RC230398 – Applicant DJ Jones and NR Searell Family Trust.  
Application for Subdivision Consent Terrace Street, Bannockburn  
Hearing Summary of Landscape & Visual Effects Assessment  
Prepared for Central Otago District Council  
Yvonne Pfluger

5 March 2025

**Appendix 1: Relevant Map CENTRAL OTAGO DISTRICT RURAL REVIEW  
Landscape Assessment  
Prepared by LA4 Landscape Architects 2007**

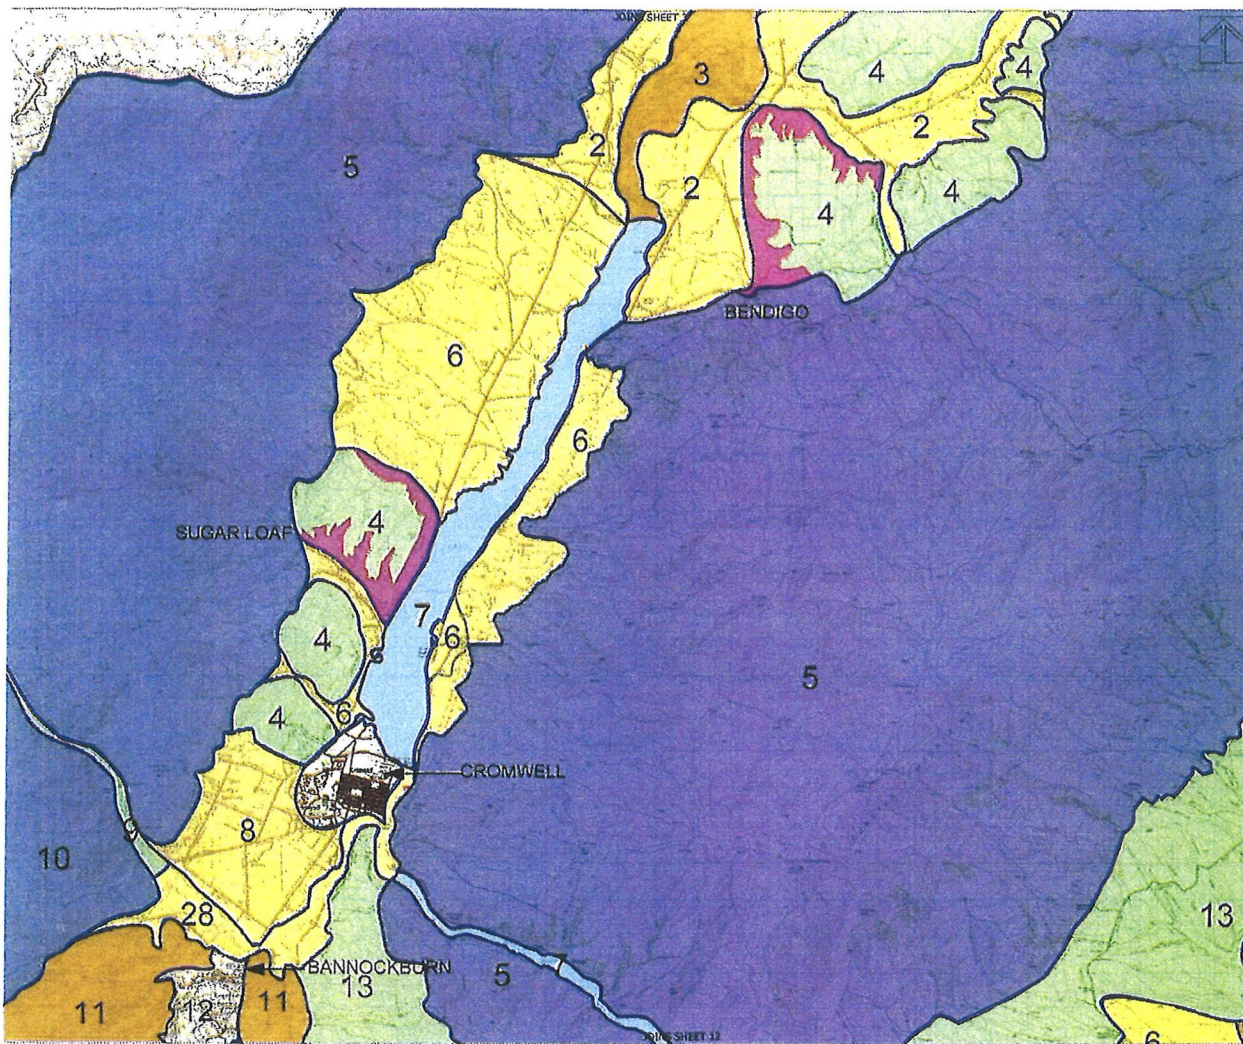
- 2.6 I attached the relevant page from the Central Otago District Rural Review Landscape Assessment prepared by LA4 Landscape Architects in 2007. I understand this assessment informed the identification of Outstanding Natural Landscapes (under RMA S6b) and Significant Amenity Landscapes (under RMA S7c) in the current Central Otago District Plan. While this study identified the terraces around Benidgo and Lowburn/ Sugar Loaf as significant landscape features, the subject site was identified as "moderate sensitivity".
